Subject: NRR/DRA/APOB Preliminary Analysis of 1D dam breach modeling runs for the flooding evaluation of the Oconee Nuclear Station (ONS) due to an upstream dam failure

## GENERAL COMMENTS

# COMPARISON BETWEEN OUTPUT RESULTS FOR GROUPS 1, 2, AND 3

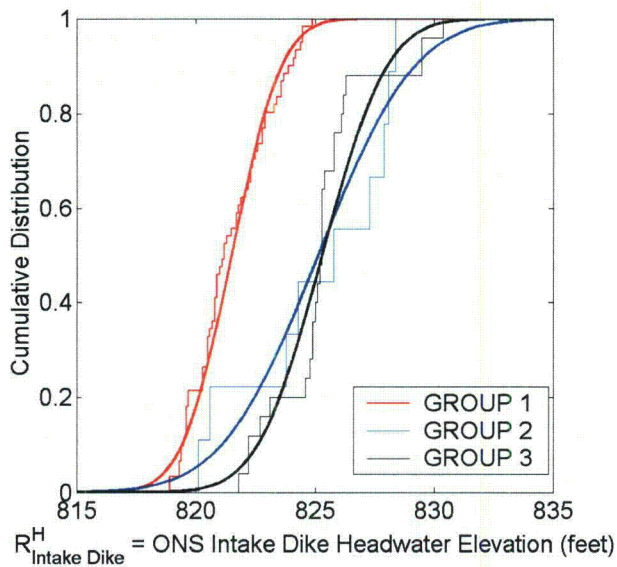
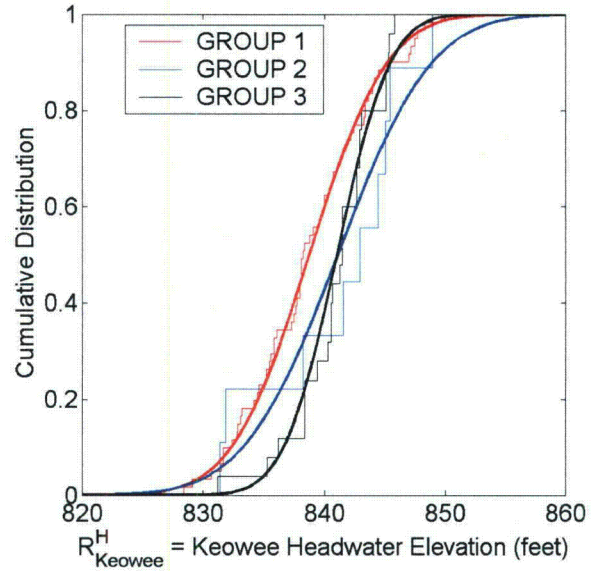
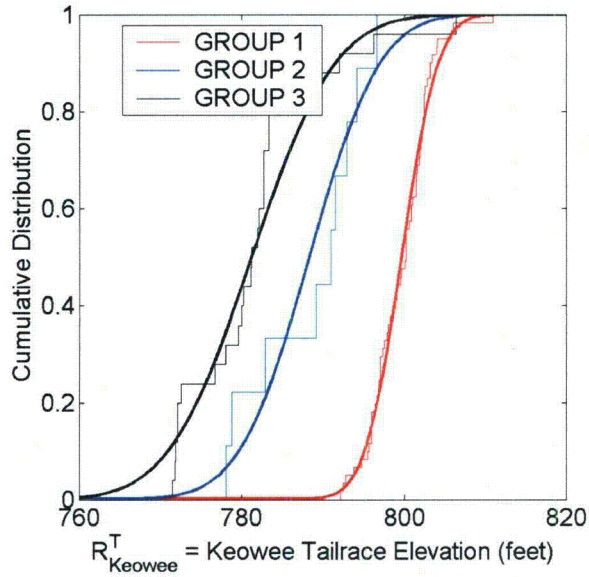
- The group 1 subset of Manning's coefficients (all values equal to 0.035) causes smaller outputs of the ONS Intake Dike Headwater Elevation and higher results for the Keowee Tailrace Elevation. The smaller subset of results for the Keowee Headwater Elevation does not appear to show statistically significant differences between the three Manning's coefficient groups.

**ATTACHMENT C1**

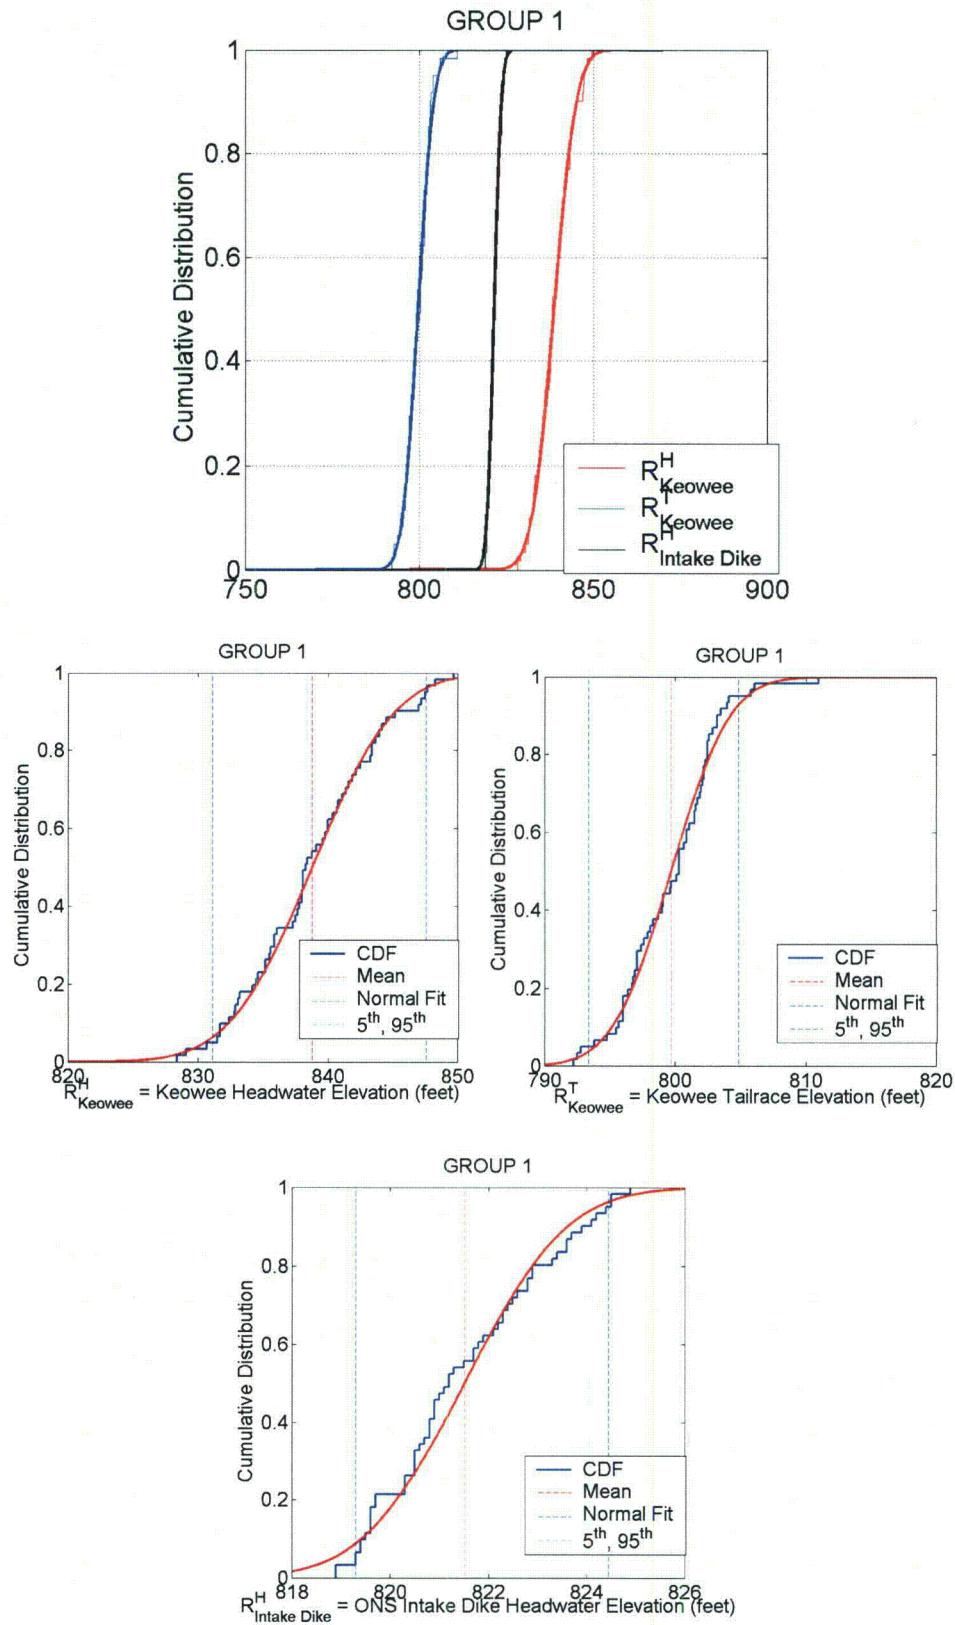
- For Group 1 Manning's coefficient input parameters, the most significant contributors to an increase in  $R_{Keowee}^H$  appear to be a decrease in the Jocassee Dam Failure Time and an increase in the Jocassee Piping Elevation (see Attachment C1 for output variation in other parameters).

**ATTACHMENT C3**

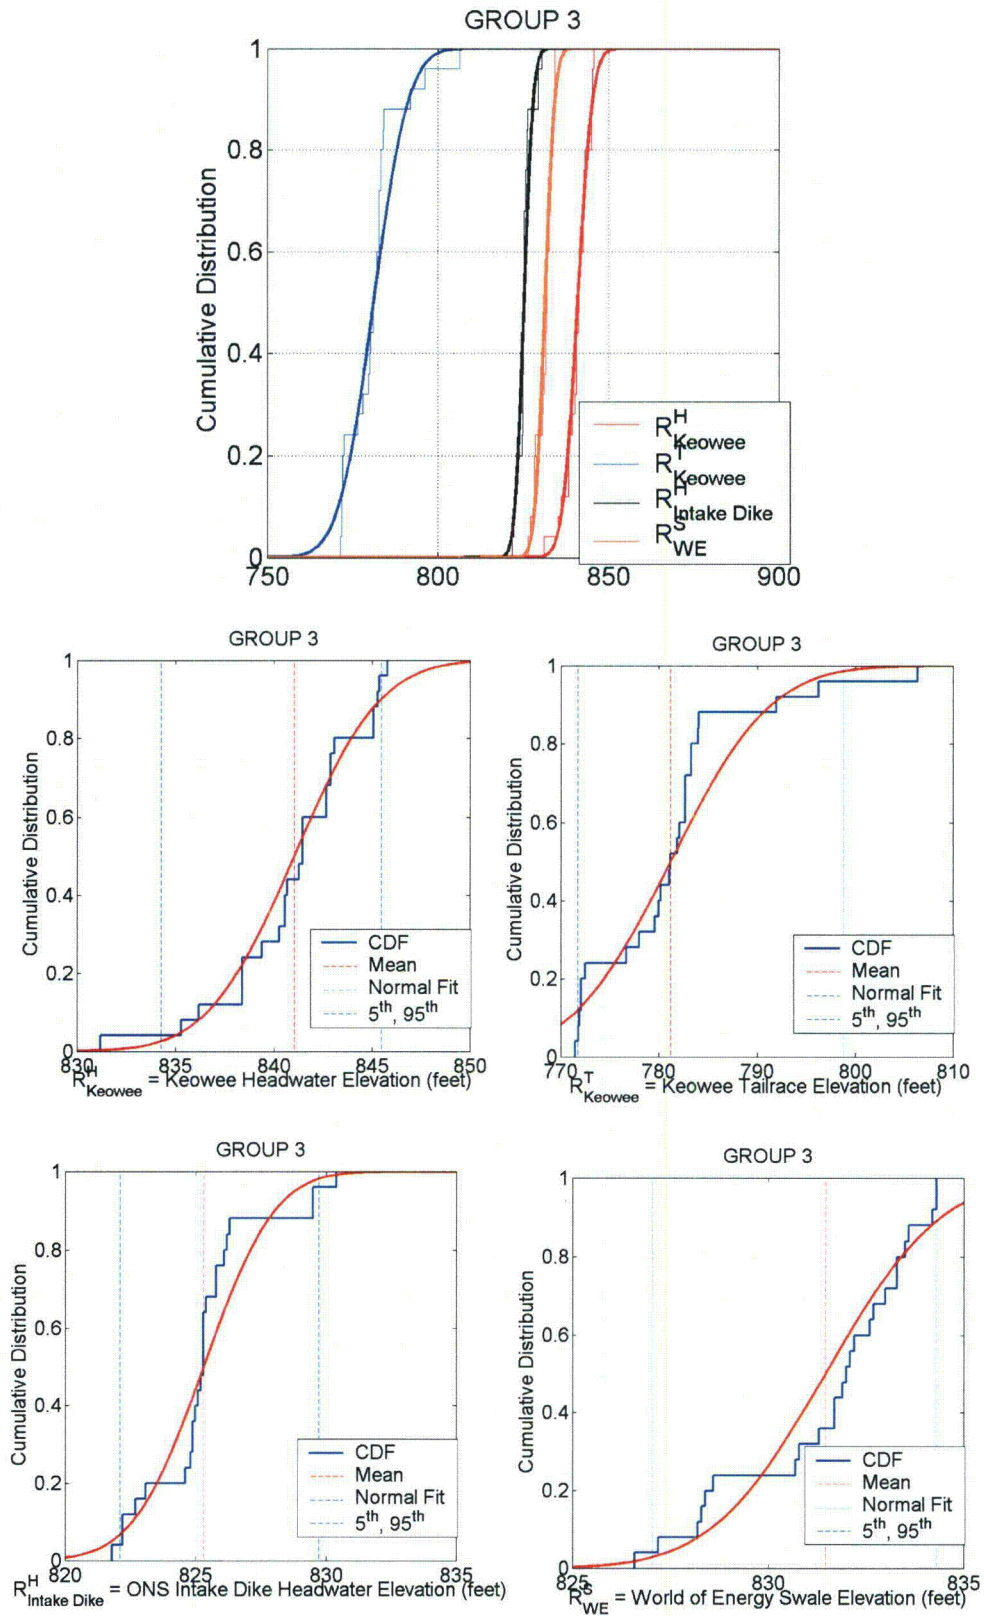
- For Group 3 Manning's coefficient input parameters, the most significant contributor to an increase in  $R_{Keowee}^T$ , appears to the exclusion of Saddle Dam failures. For other parameters, few samples were used to assess the sensitivity to various input values (see Attachment C3 for output variation in other parameters).
